## Executive Director's Recommendation

<b>PROJECT</b> <b>Surgery, Radiology and Lab Medicine Building Addition</b> National Institutes of Health, Bethesda Campus 9000 Rockville Pike Bethesda, Maryland	<b>NCPC FILE NUMBER</b> 8235
<b>SUBMITTED BY</b> United States Department of Health and Human Services National Institutes of Health	<b>NCPC MAP FILE NUMBER</b> 3101.20(38.00)45272
<b>REVIEW AUTHORITY</b> Federal Projects in the Environs per 40 U.S.C. § 8722(b)(1)	<b>APPLICANT'S REQUEST</b> Approval of final site and building plans
	<b>PROPOSED ACTION</b> Approve final site and building plans with comments
	<b>ACTION ITEM TYPE</b> Staff Presentation

# National Institutes of Health Surgery Radiology Laboratory Medicine Addition

Approval of Final Site and Building Plans

# December 2020 Preliminary Design

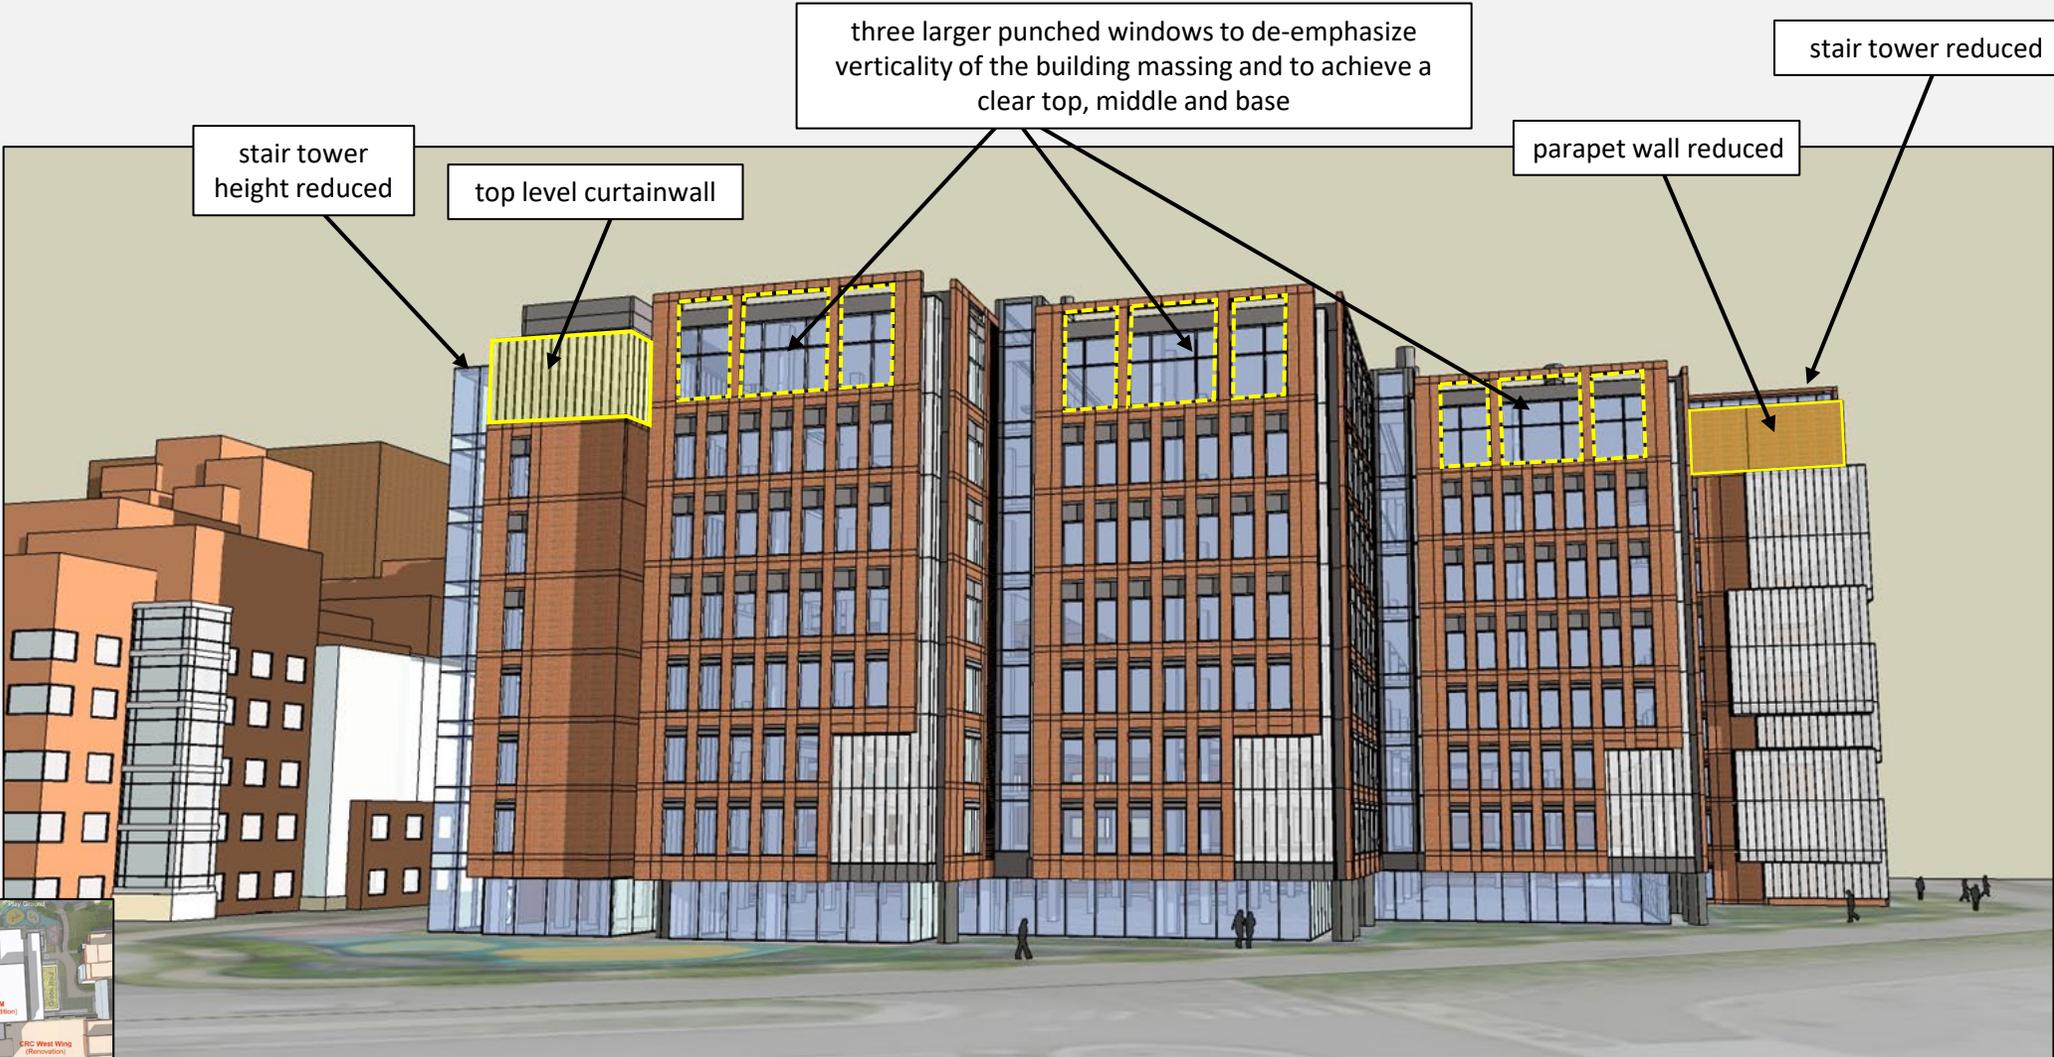
NIH has submitted a modified building design that attempts to de-emphasize the addition's vertical appearance in response to previous NCPC comments to refine the massing and design of the new addition. Since December, NIH has worked with staff on different design alternatives. Initially NIH proposed greater use of metal and glass cladding; modified stacked glass corner cubes; and horizontally oriented glass along the building corners. Staff did not find these alternatives to improve the initial design so per staff direction, NIH produced the current proposal which draws on the materials/design elements of the initial design. Updated plans and project renderings show several notable changes that include lowering the heights of the stair towers and west-wing parapet wall; reconfigured punched windows; and a new glass curtainwall section. NIH intends these changes to reduce the perceived scale of the project, and to help achieve a more defined building top relative to its middle and base sections.

One last notable design change relates to the stacked cubes located on the corner of the new SLRM addition closest to the Center Drive/Convent Drive intersection. The previous design shows the cubes comprised of a mix of clear and translucent glass, whereas the new design shows the cubes constructed of all vision glass with ceramic frit. Though the change does not diminish the overall scale of the project, NIH did modify the cube glass based on comments made by the Commission during its December review.

North Elevation

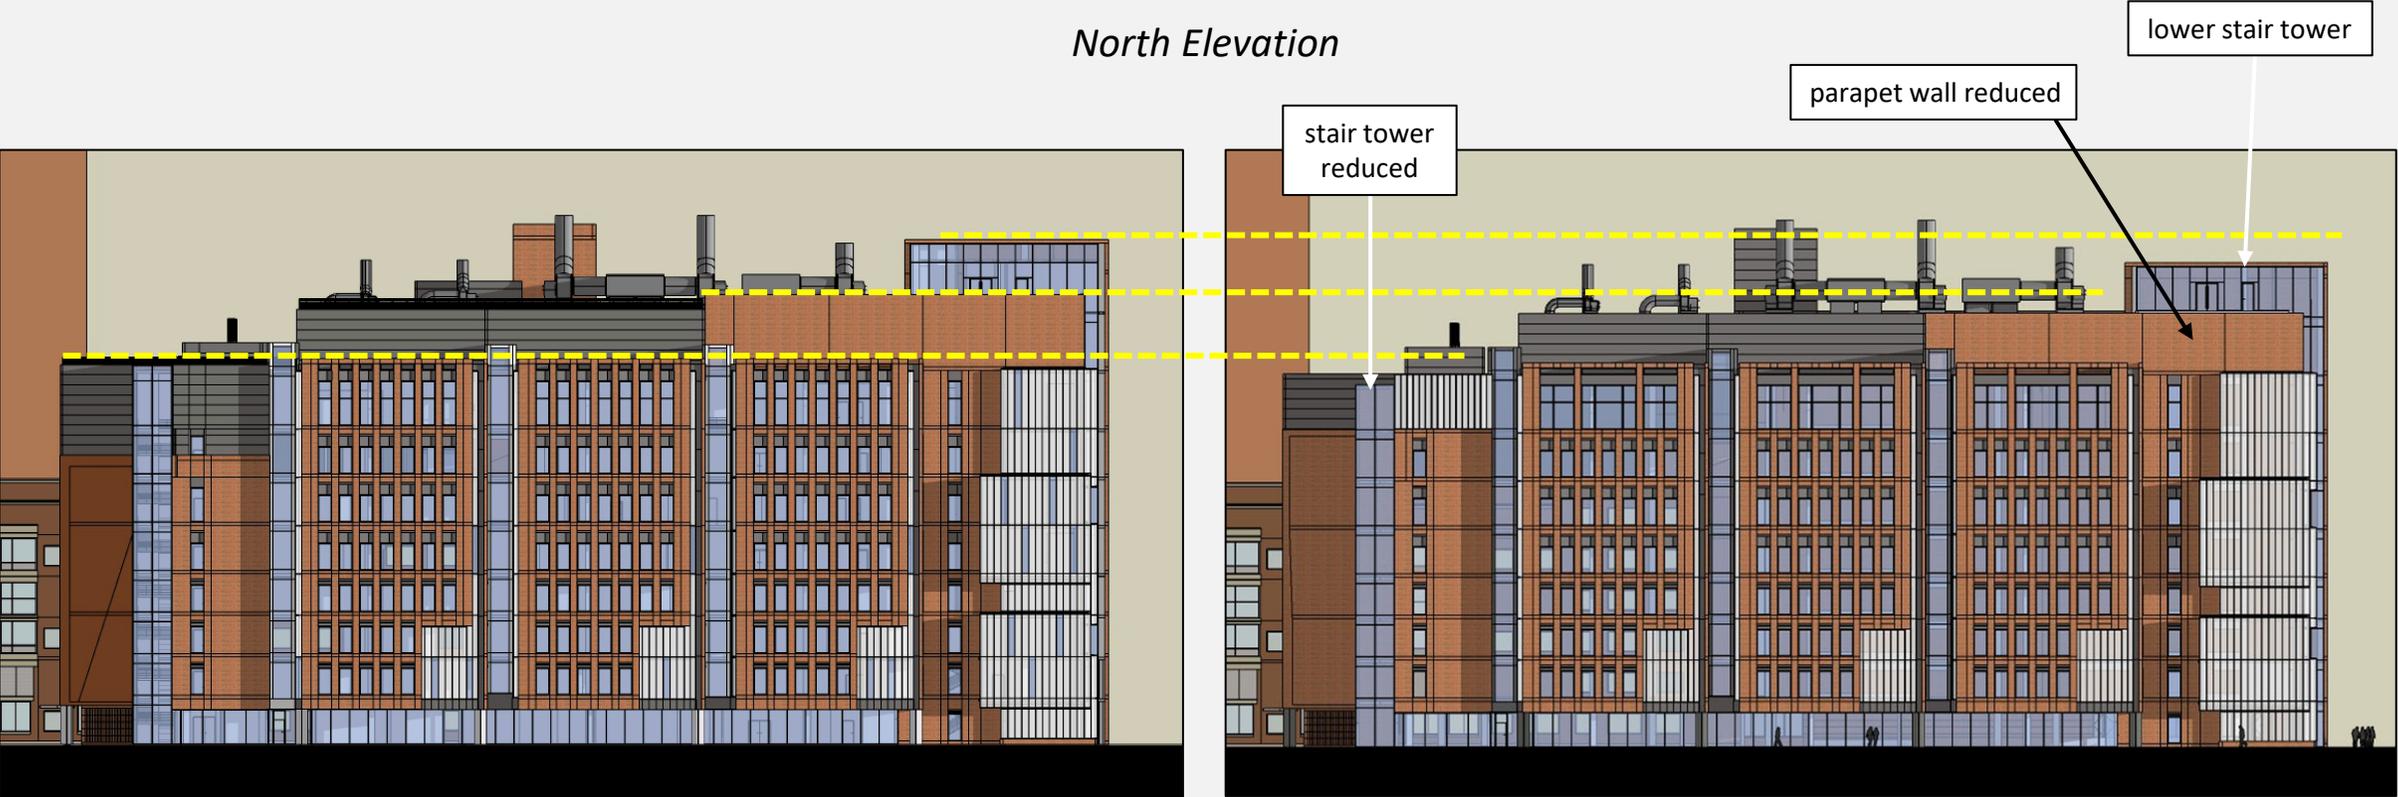
- Reducing the heights of the stair towers and west-wing parapet wall;
- Replacing seven, more vertical (rectangular) punched windows with three larger punched windows at the top of the building's three north-facing wings; and
- Changing the metal panel cladding on the top level of the east stair tower to a glass curtainwall.

three larger punched windows on each wing

North Elevation

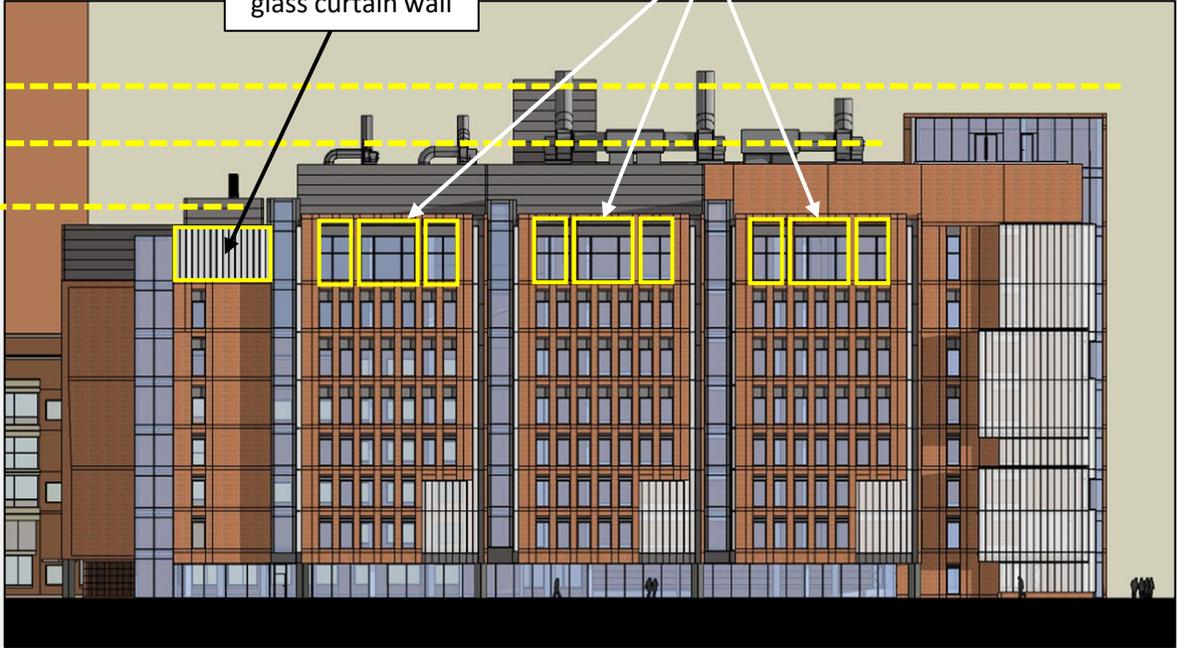
reduced stair tower height provides stronger relationship to existing CRC stair tower to the east

top level metal panel changed to glass curtainwall to reflect the sky - to visually de-materialize top floor

West Elevation

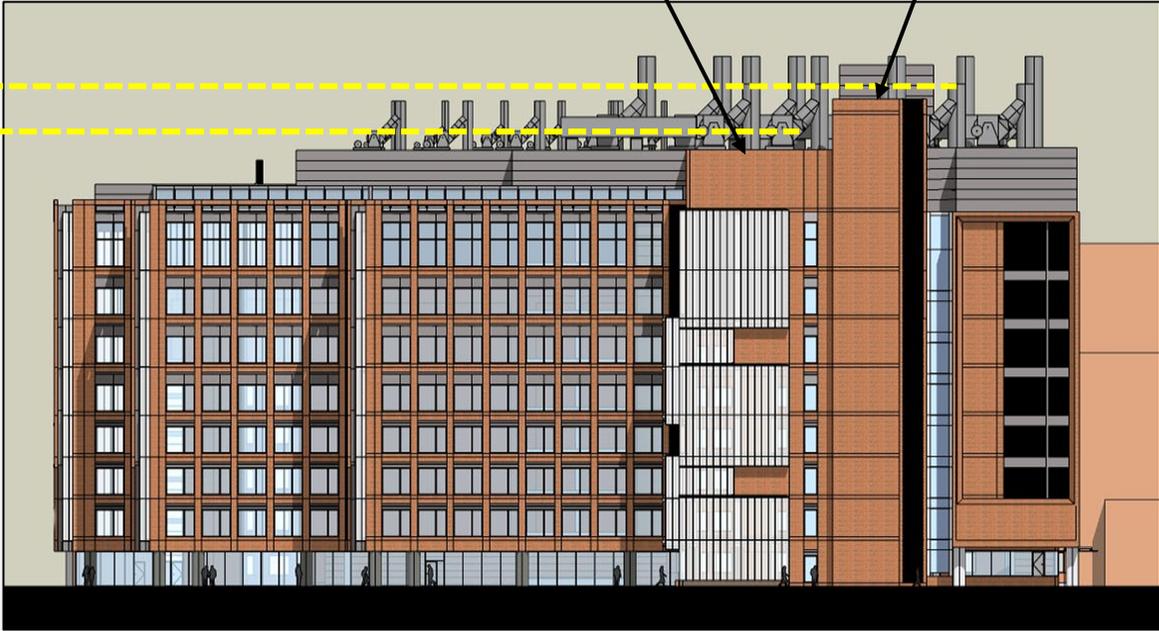
parapet wall lowered

stair tower reduced
